Livestock Plaza/Sheep Barn

Addendum Issue Date: 8/8/24

The following changes, revisions, or clarifications shall be made to the drawing documents.:

4 ALUM. WINDOW/DOOR @ MASONRY WALLS
3" = 1'-0"

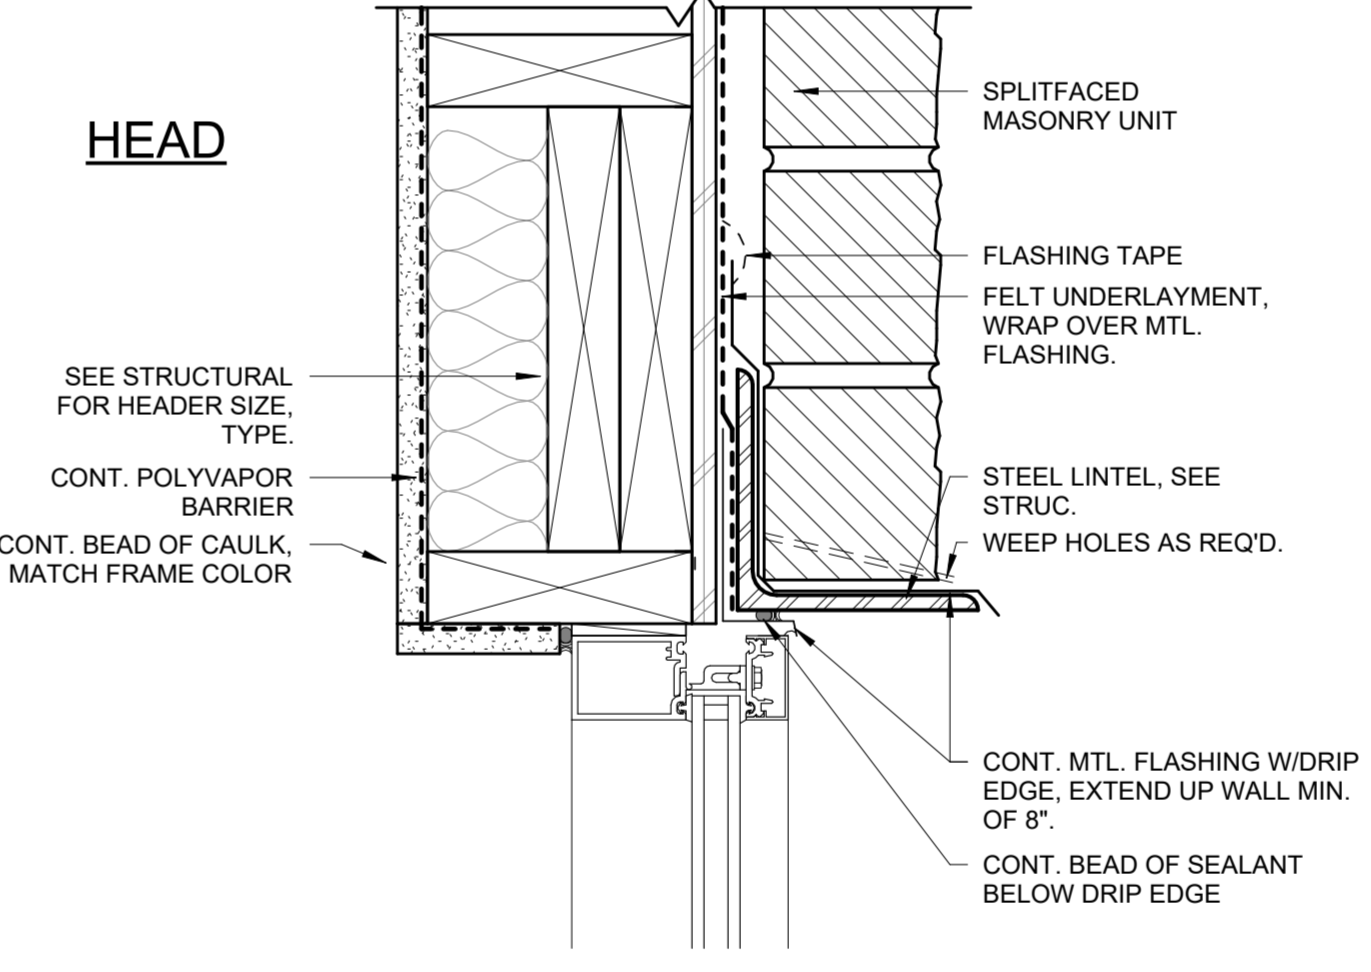
Sheet A7.2 – Door and Window Details:

Door detail revised.

SHEET:
M1.1

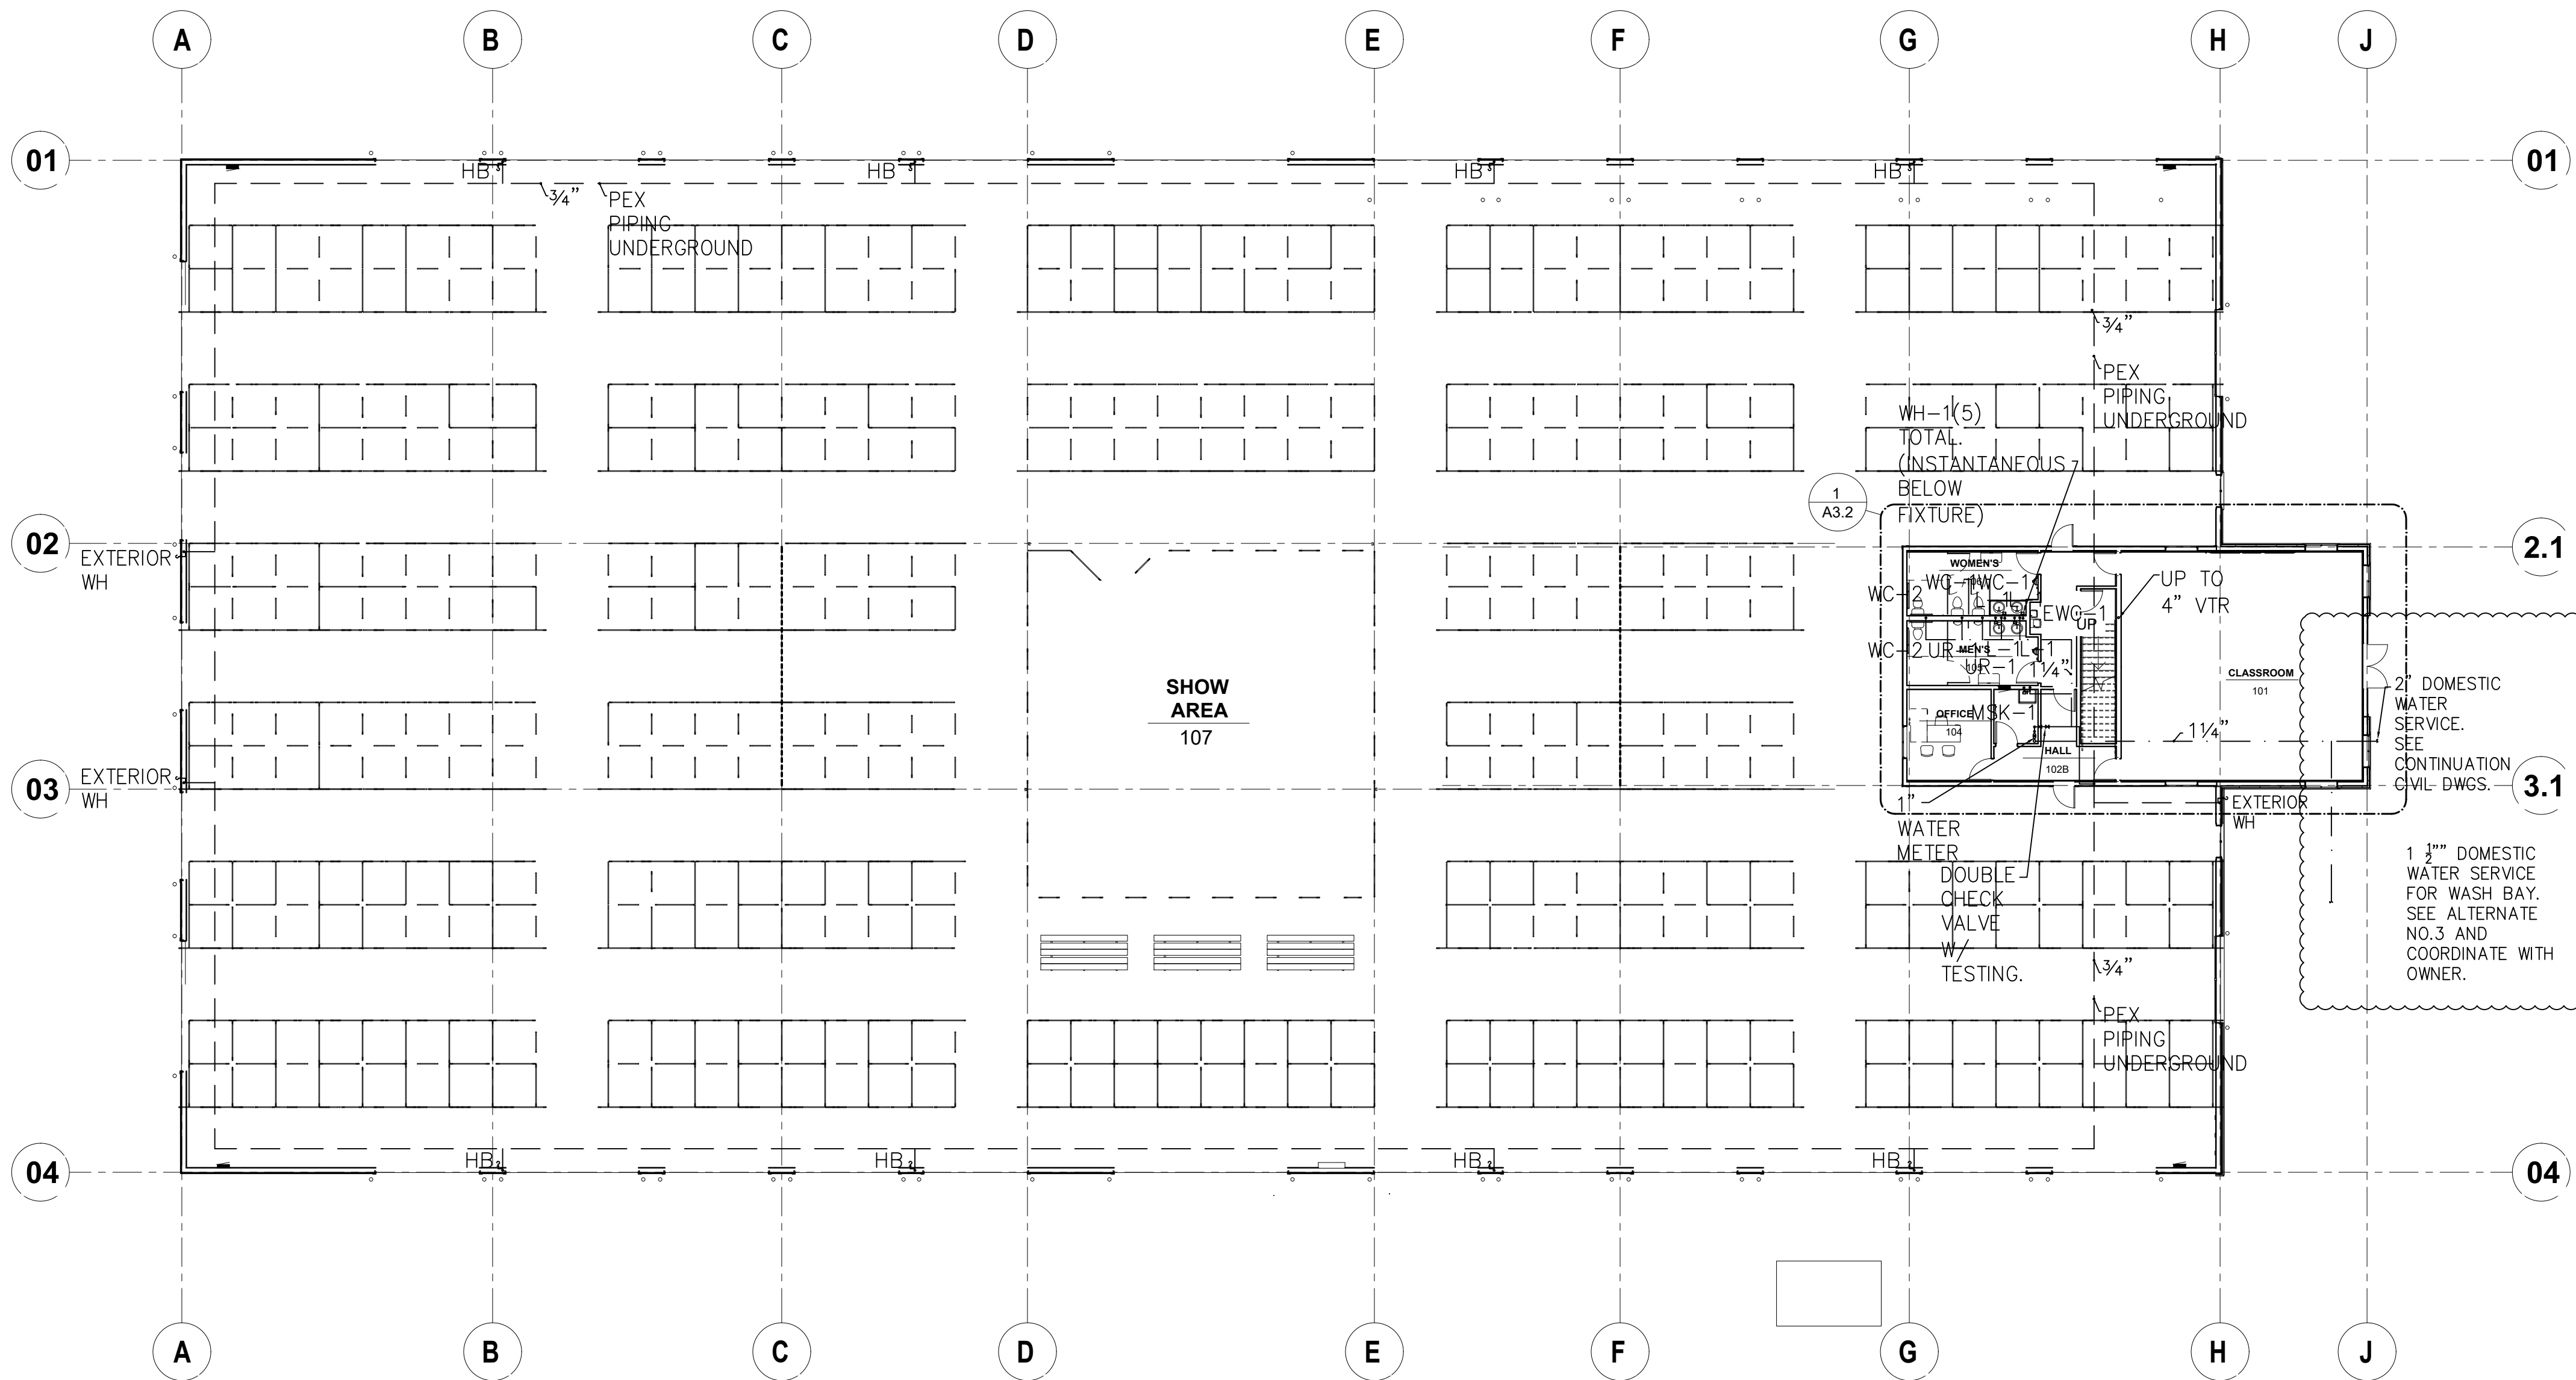
Sheet M1.1 – Under Floor Wastewater Plan:

Revision to floor drain.

SHEET:
M1.2

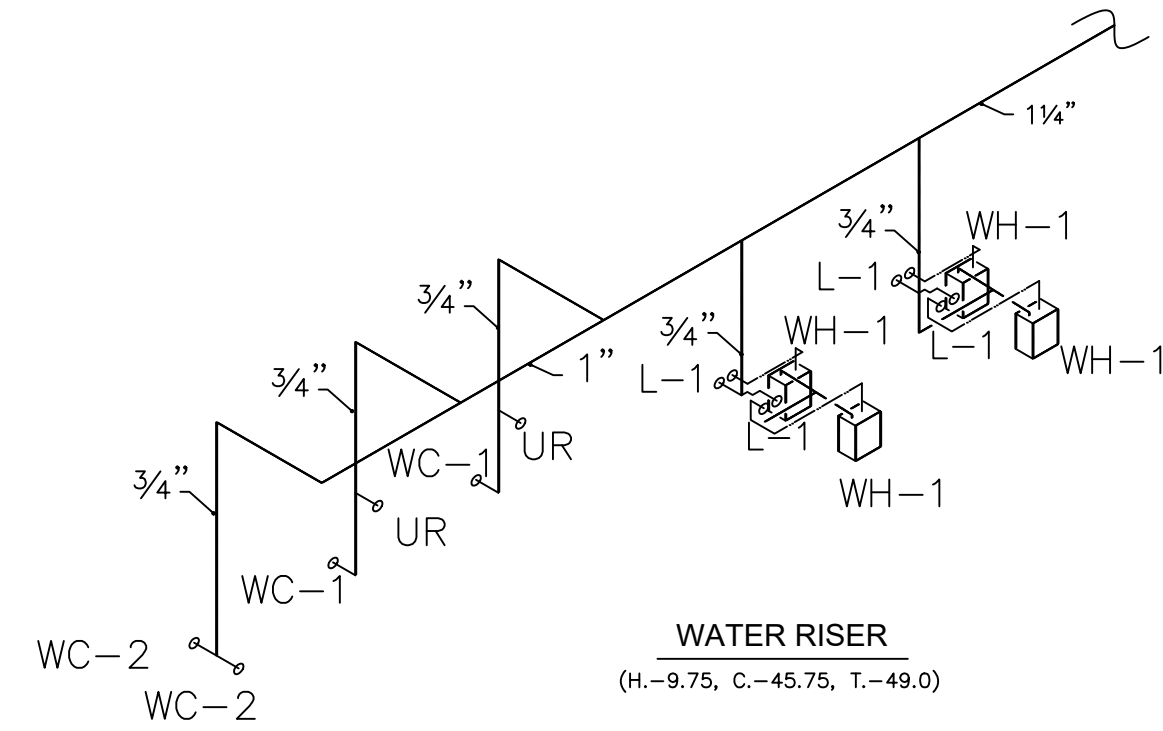
Sheet M1.2 – Water Piping Plan:

Revision to water service line.

SHEET:
M2.1

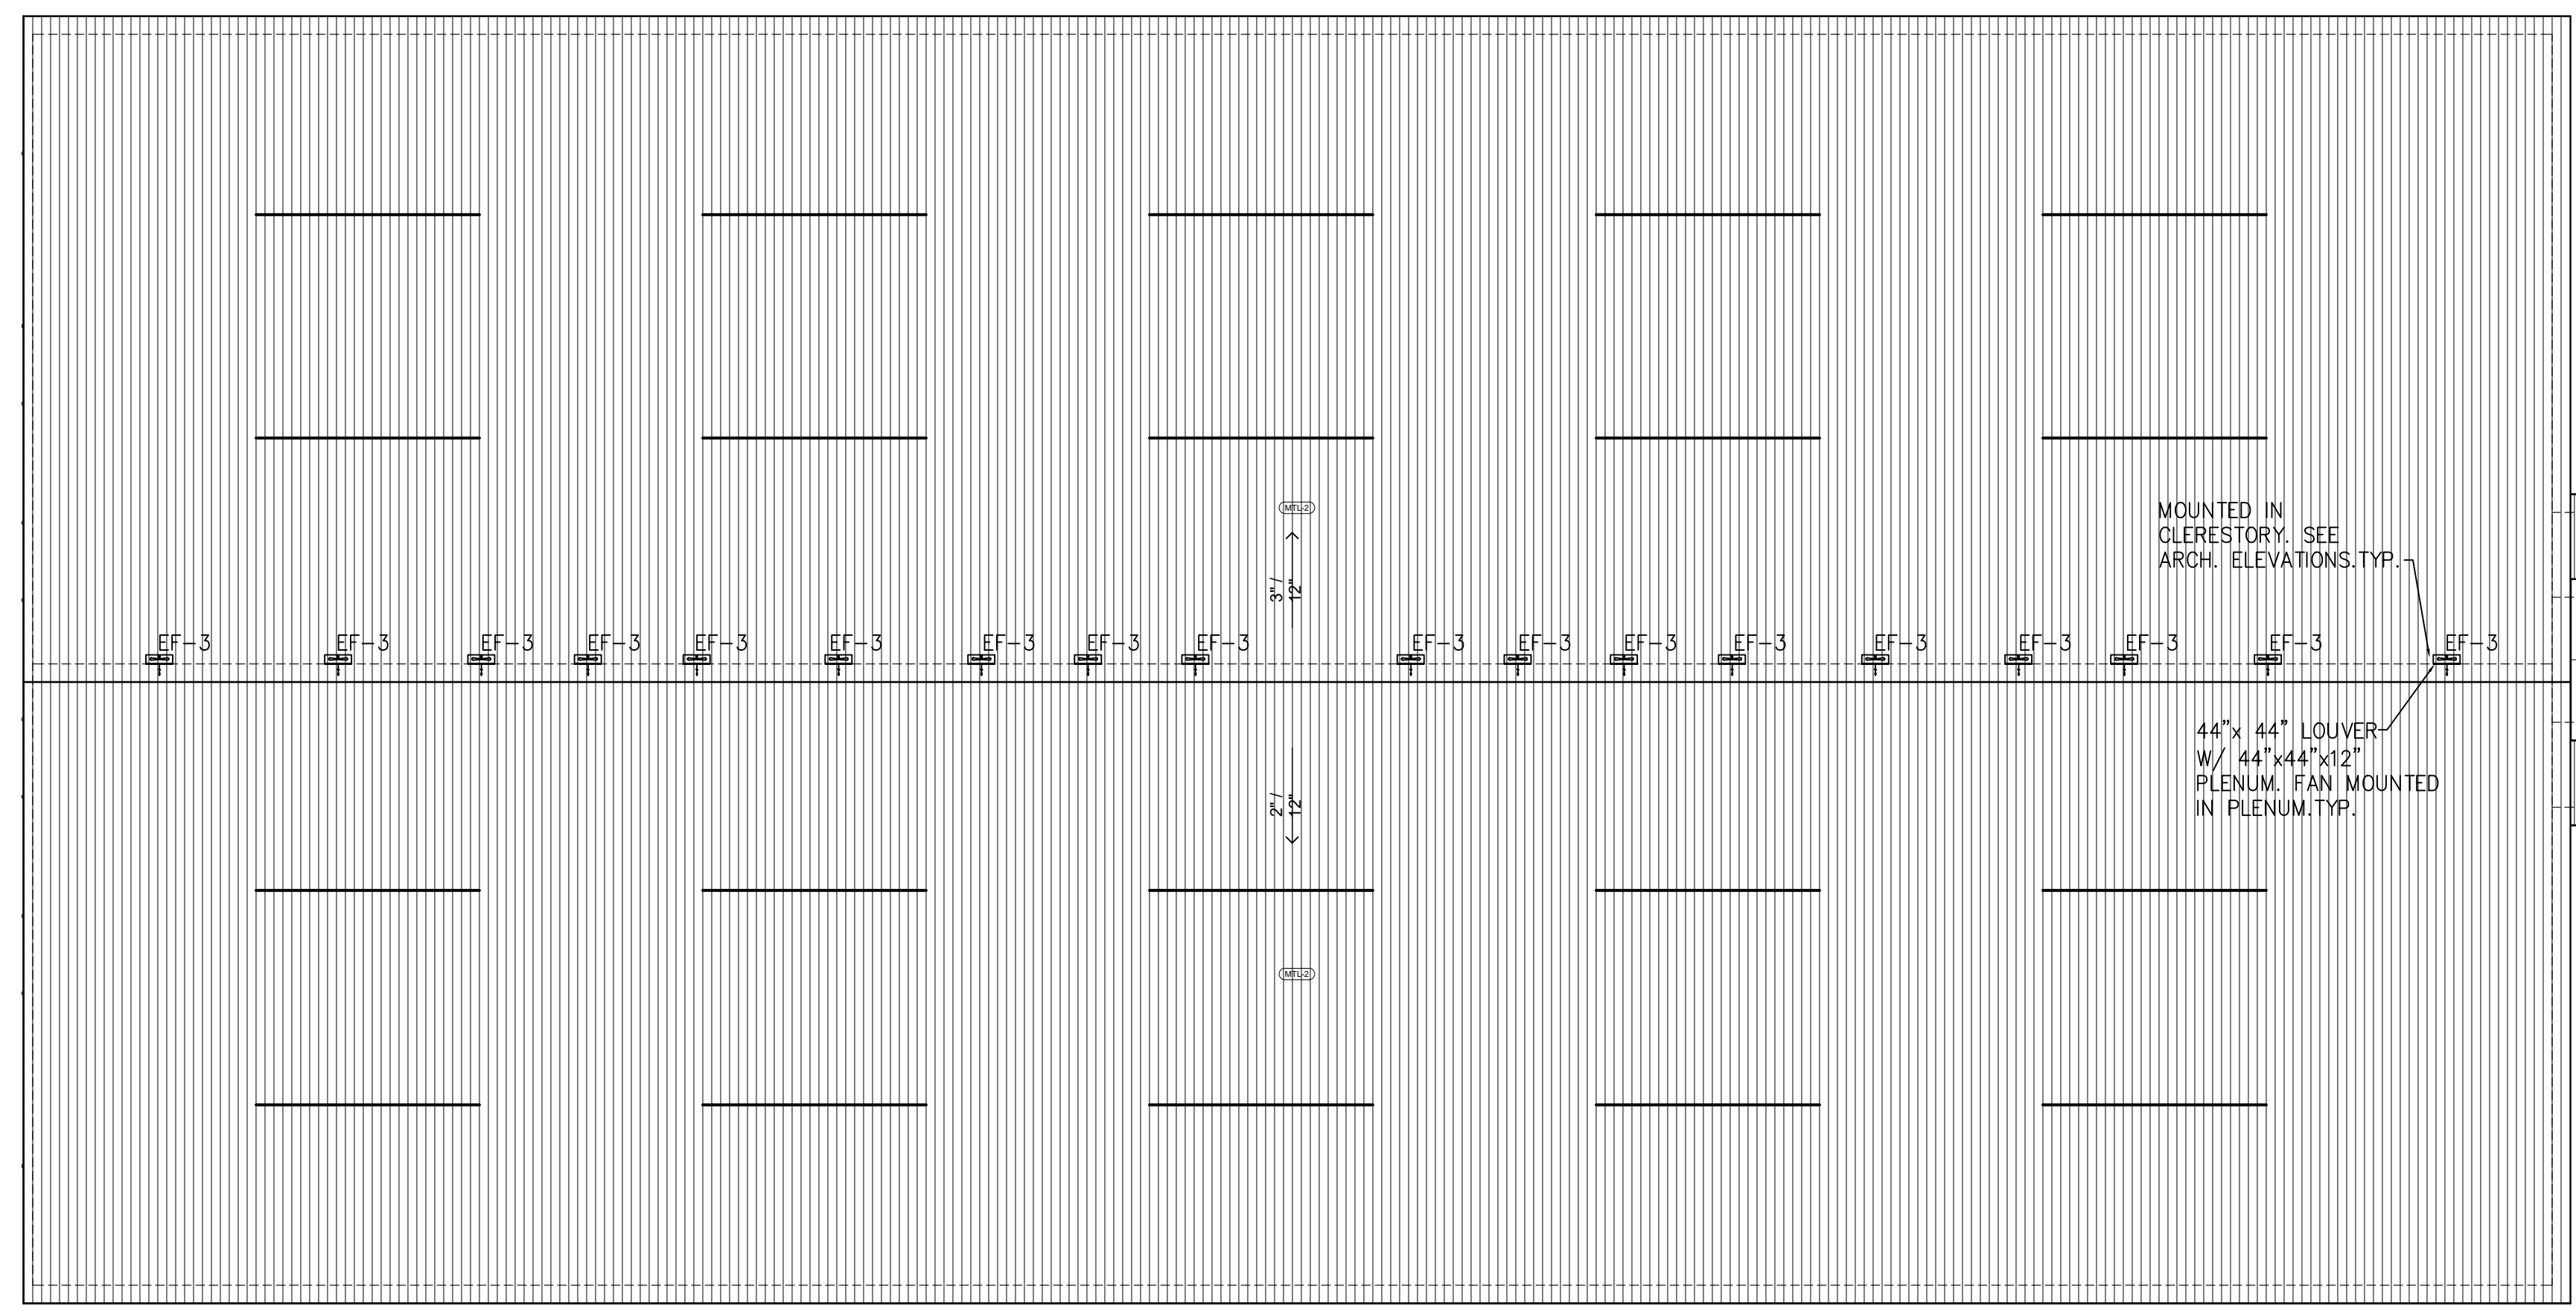
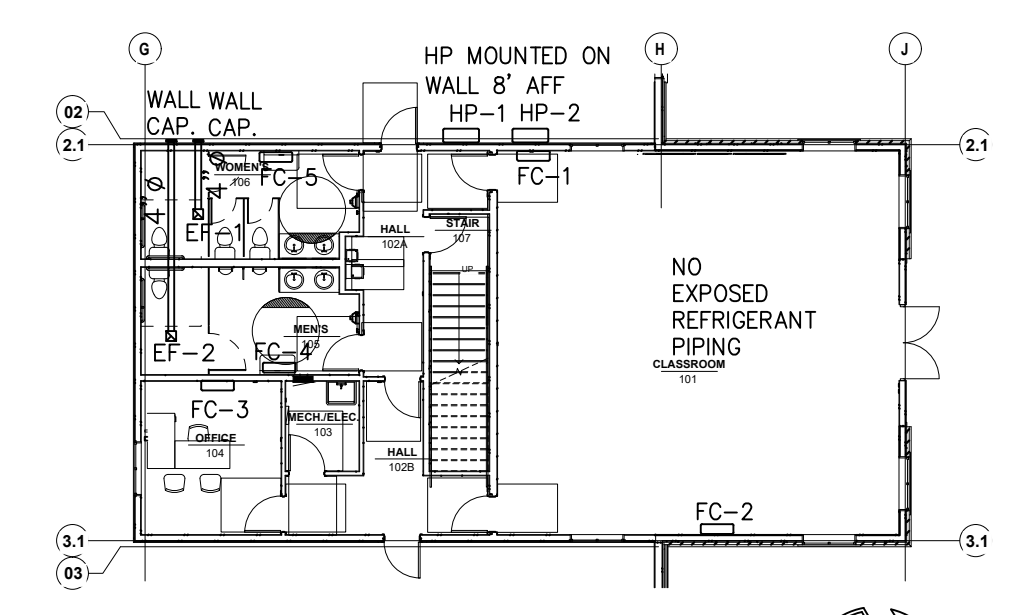
Sheet M2.1 – HVAC Plan:

Condensate drain updates.

CONDENSATE DRAIN
 FC-2 PIPE CONDENSATE DOWN AND SPILL ON GRADE.
 FC-1 PIPE CONDENSATE THROUGH WALL AND SPILL ON EXTERIOR GRADE.
 FC-3 AND FC-4 PIPE CONDENSATE THROUGH WALL AND SPILL TO MOP SINK.
 FC-5 PIPE CONDENSATE DOWN TO FLOOR DRAIN BELOW FAN COIL.
